Access Compliance Report

Public Rights-of-Way

(Curb Ramps)

Intersection ID: N/A	Main Street: TIFFANY_ROSE_PL	Cross Street: W_CRAIGHEAD_RD	Location: NE
ADA ID: 1226741332C3	Ramp Type: Combination1Diag	Initial Pass/Fail: Fail	Overall Compliance: No
		Severity Score: 0

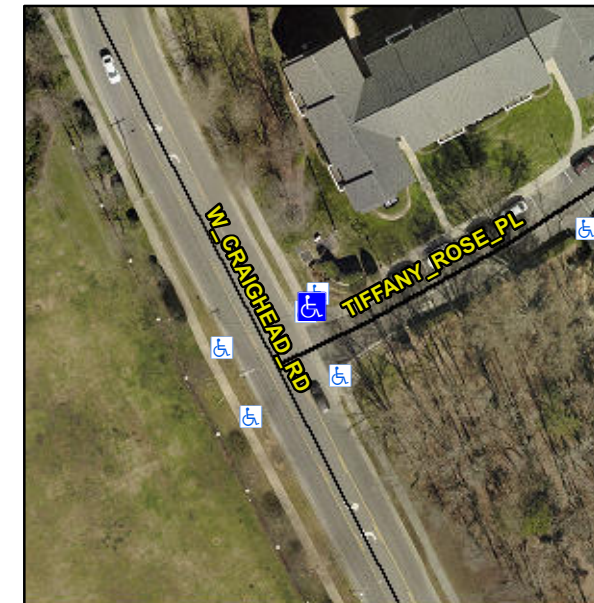
Not Found, R304.5.1, R304.5.3, R304.3.2

Compliance	Description	Data	Compliance	Description	Data
N/A	Ramp Length LT (in)	32.0	N/A	Ramp Length RT (in)	39.0
Yes	Ramp Width LT (in)	58.0	Yes	Ramp Width RT (in)	63.0
No	Ramp Slope LT (%)	12.0	Yes	Ramp Slope RT (%)	1.8
Yes	Ramp XSlope LT (%)	1.6	No	Ramp XSlope RT (%)	2.6
N/A	Ramp Length (in)	22.0	Yes	Ramp Slope (%)	4.3
No	Ramp Width (in)	45.0	No	Ramp XSlope (%)	3.7
N/A	Flare Type LT	N/A	N/A	Flare Type RT	N/A
N/A	Flare Slope LT (%)	N/A	N/A	Flare Slope RT (%)	N/A
N/A	Flare Traversable LT?	N/A	N/A	Flare Traversable RT?	N/A
N/A	Landing Length (in)	N/A	N/A	DWS Provided?	N/A
N/A	Landing Width (in)	N/A	N/A	DWS Contrast?	N/A
N/A	Landing Slope (%)	N/A	N/A	DWS Length (in)	N/A
N/A	Landing X Slope (%)	N/A	N/A	DWS Full Width?	N/A
N/A	Landing Curb? (Y/N)	N/A	N/A	DWS Offset (in)	N/A
N/A	Shared Landing?	N/A			
N/A	Gutter Ponding?	N/A	N/A	Gutter Slope (%)	N/A
N/A	Gutter Lip Ht (in)	N/A	N/A	Gutter X Slope (%)	N/A
N/A	Painted X Walk1?	No	N/A	Painted X Walk2?	No

Remove & Replace Curb Ramp With Two New Directional Ramps or Equivalent.
